Final Reclamation Inspection

Operator: PDC ENERGY INC - 69175

Location ID: 331521

Inspection Photos
Location Name: FOE 33-20
Location ID: 331521

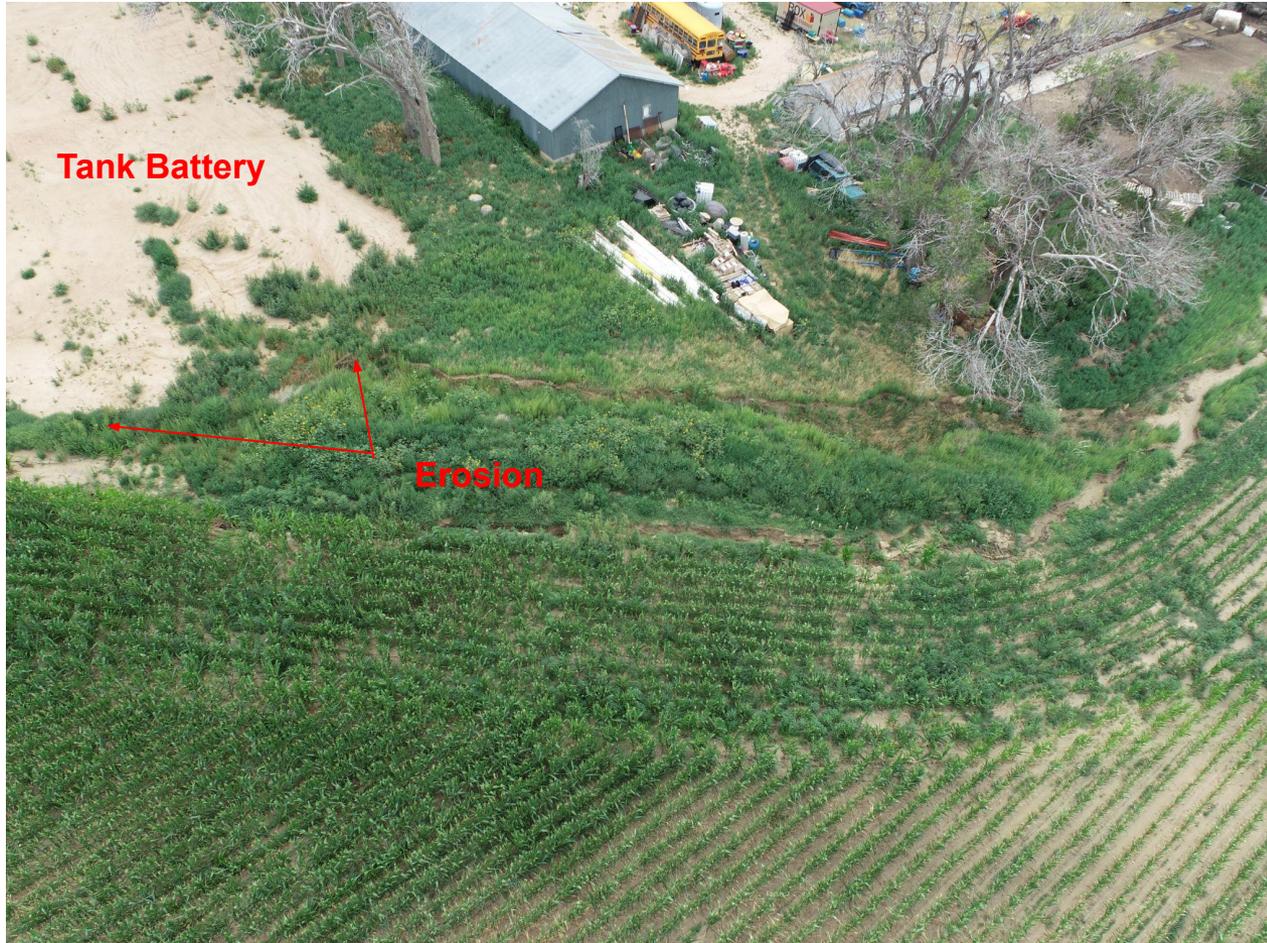
Photo 3. Overview photo of tank battery using a drone (looking southeast [up]). Photo illustrates that the tank battery does not comply with rule 1002.f. It appears that irrigation water from the adjacent crop fields are draining towards the western portion of the tank battery. This is causing channelized flows that are causing gully erosion associated with the site.
